Date of Document	18/10/24
Originator	Ian Chalmers
Originator's Ref (if any)	
Document Title	Musselburgh Flood Protection Scheme MLS report - Appendix A.9

I am writing to object to the recently published Musselburgh Flood Protection Scheme.

Figure 3

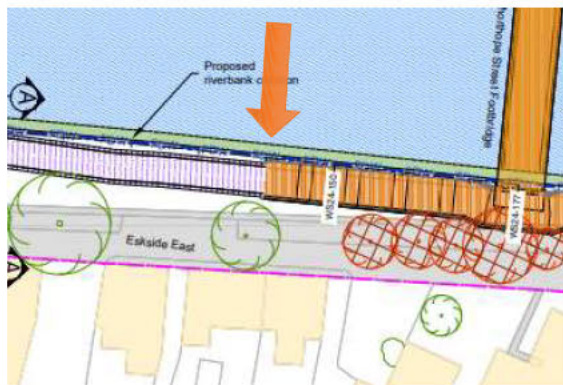
The Shorthope Street Bridge placement in the proposed scheme shows that the bridge will now face more towards residential properties (See **Figure 3**).

I have a significant concern that people actively using the bridge (to be used to go onto the new travel path as a commuting route on a regular basis), will have [REDACTED] This affects my way of life.

Furthermore, having a bridge positioned in this way could [REDACTED] and I have a concern that the value of my property will be adversely affected because of this. The scheme does not mention how residents in this situation will be adequately compensated as a result of this long-term structural change.

Figure 5

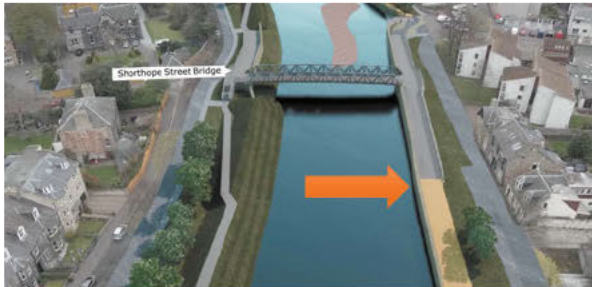
The image in Figure 3 ([X \(musselburghfloodprotection.com\)](https://www.musselburghfloodprotection.com)) suggests that the Shorthope Street Bridge ramp [REDACTED] [REDACTED] Figure 4 ([Public Exhibition No. 2 - June 2023 - Musselburgh Flood Protection](#)) shows the Shorthope Street Bridge with a ramp [REDACTED] and in Figure 5 the ramp has been omitted completely.

← Ramp has been omitted.
